STATE OF NEVADA  
Department of Conservation & Natural Resources  
DIVISION OF ENVIRONMENTAL PROTECTION

December 1, 2010

Re: **Tronox LLC (TRX)**  
**NDEP Facility ID #H-000539**  
Nevada Division of Environmental Protection (NDEP) Revised Response to:  
*Revised Excavation Plan for Phase B Soil Remediation of RZ-C, Addendum to the  
Removal Action Work Plan, Tronox LLC, Henderson, Nevada*  
Dated: September 1, 2010

## Attachment A

C-3

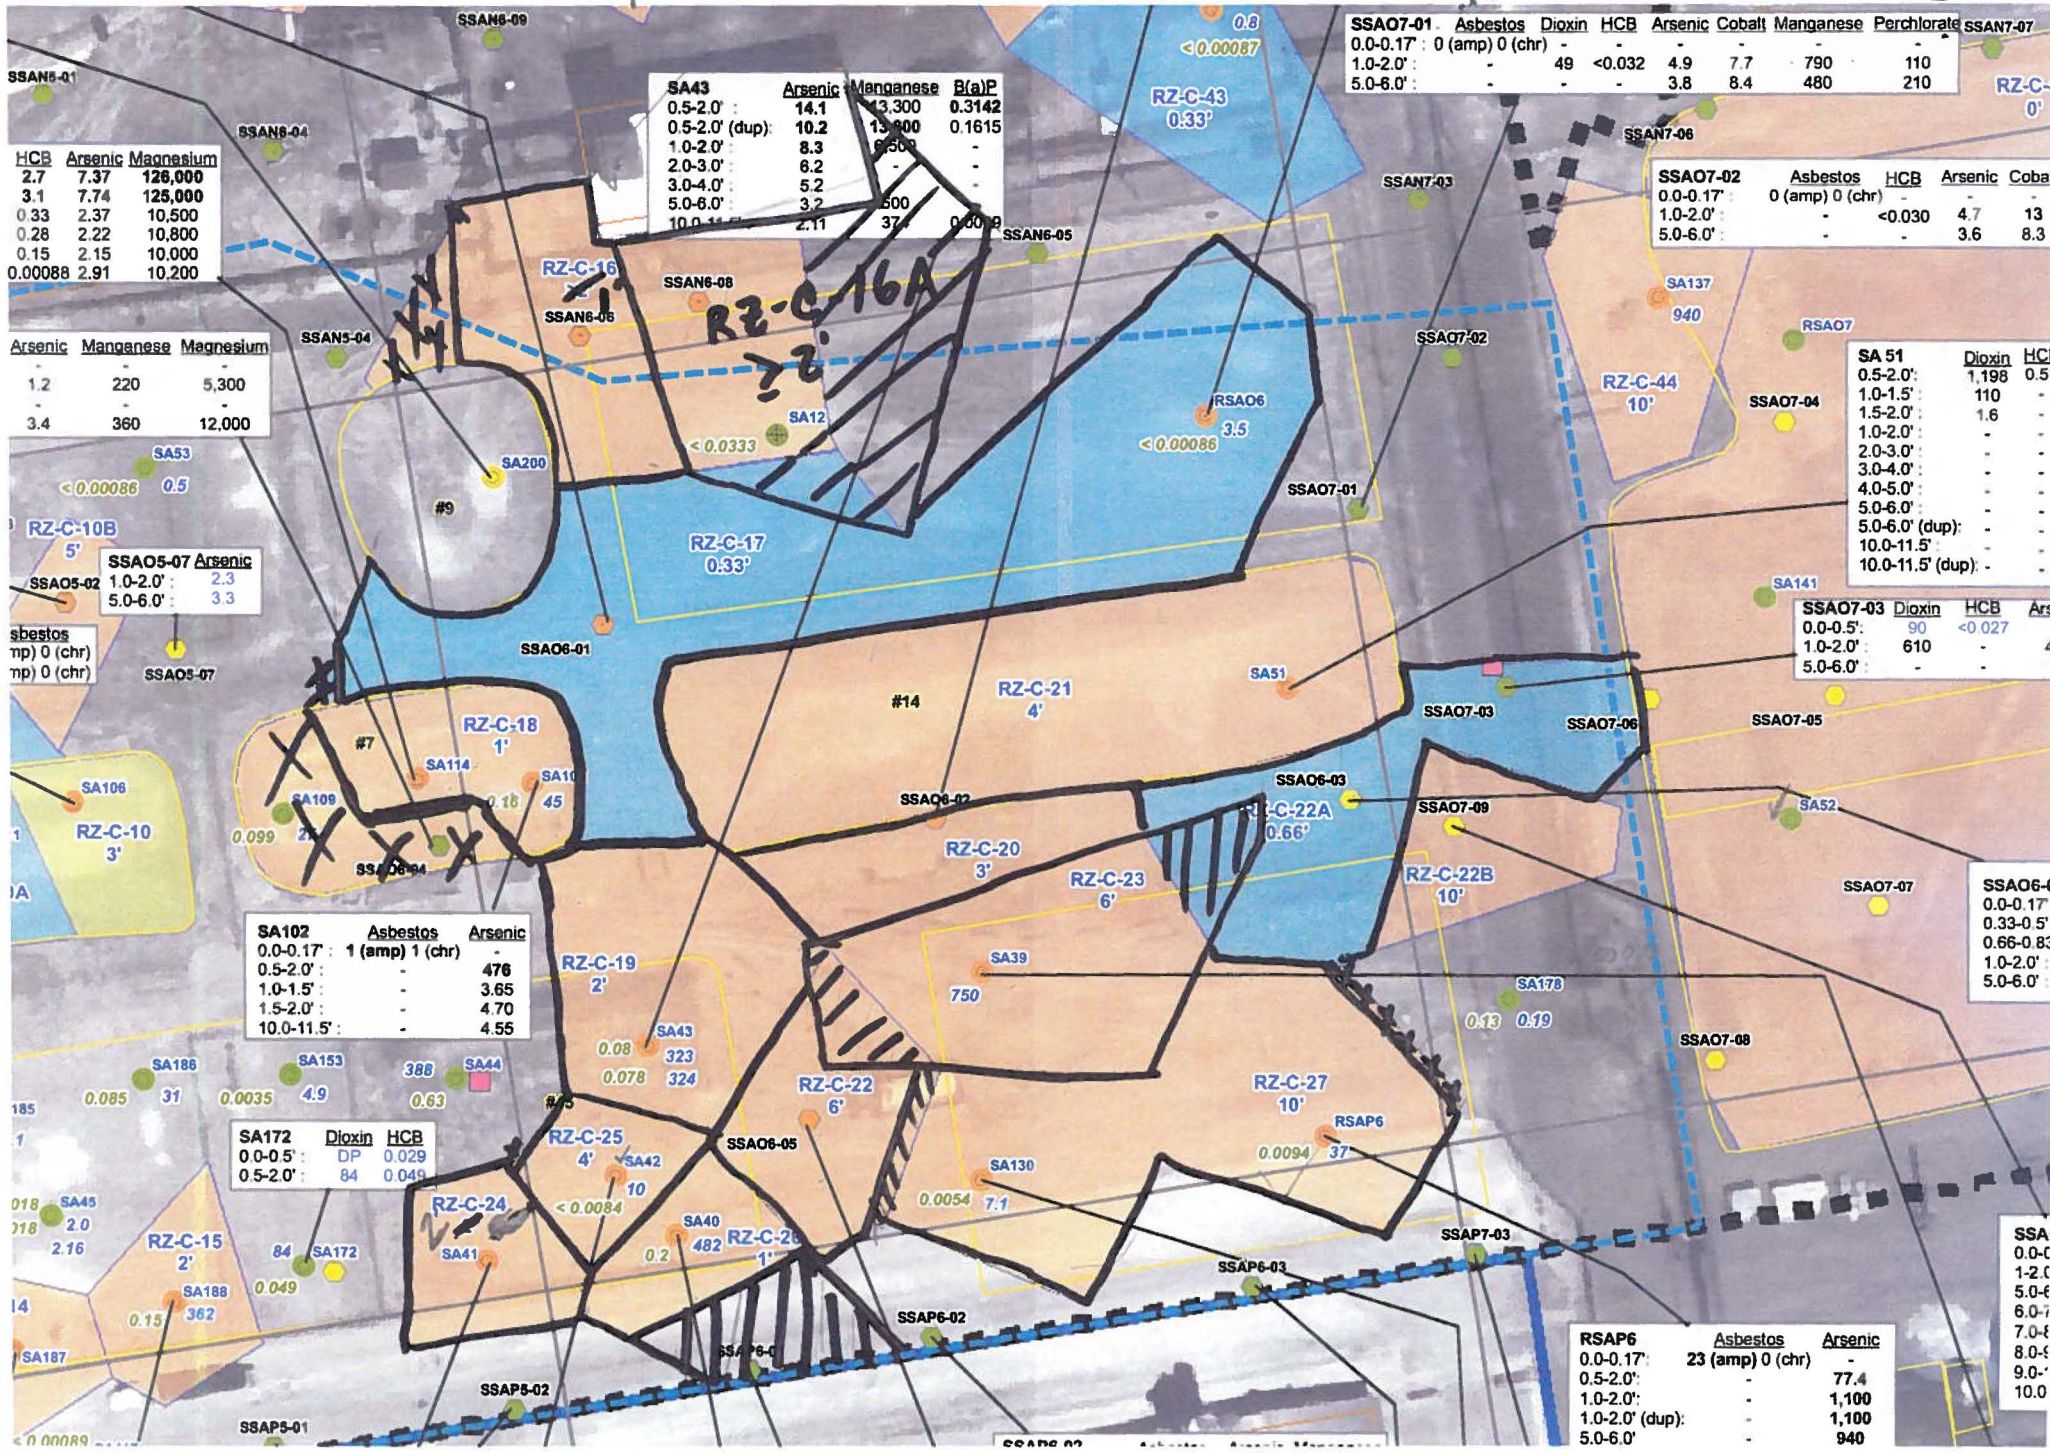
The following Figures are excerpts from Figure 1: RZ-C Excavation Areas and Nature and Extent of Contamination (dated October 12, 2010). NDEP has provided approximate revisions to excavation limits to illustrate the comments made in the Attachment B Table as well as based on comment 2 of Attachment A.

Additionally in this revised response, only Figures C-2, C-4, and C-5 have been revised. The revised depths are marked in green.

pg 21  
 \* if asbestos results in SA113 are < comparison levels

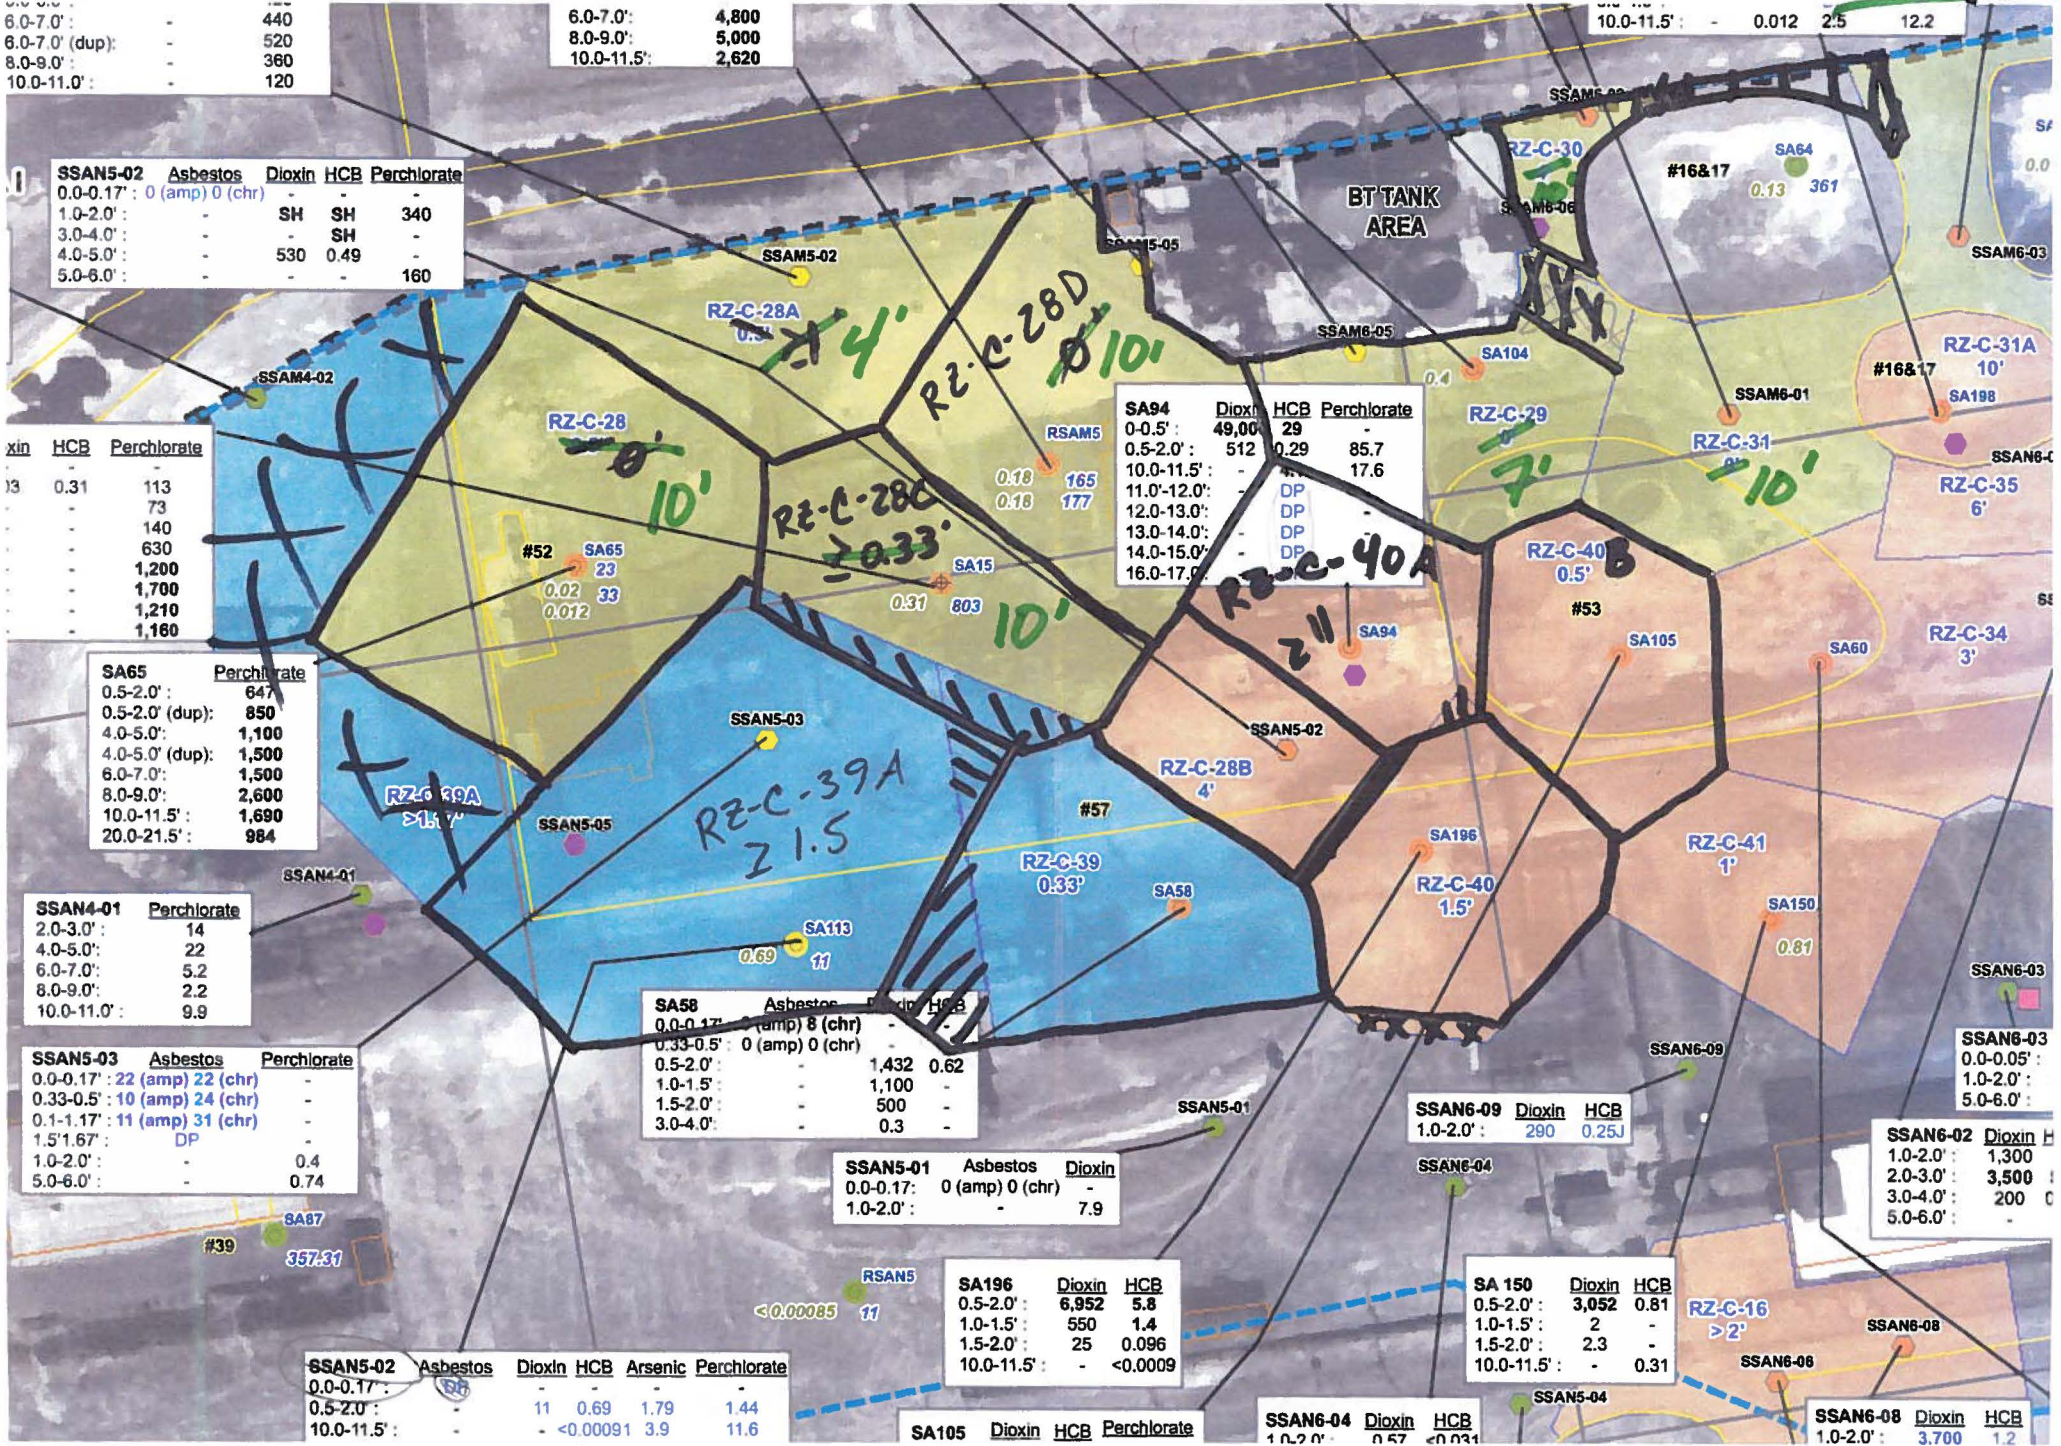
Please note that Figures C-7 and C-8 are included for the revisions that will be necessary once the asbestos results are received for SA113. Figure C-7 is for the scenario where the asbestos results are less than the comparison levels resulting in the reduction of RZ-C-39A. Figure C-8 are for the scenario where the asbestos results are greater than or equal to the comparison levels resulting in the increase of RZ-C-39A.
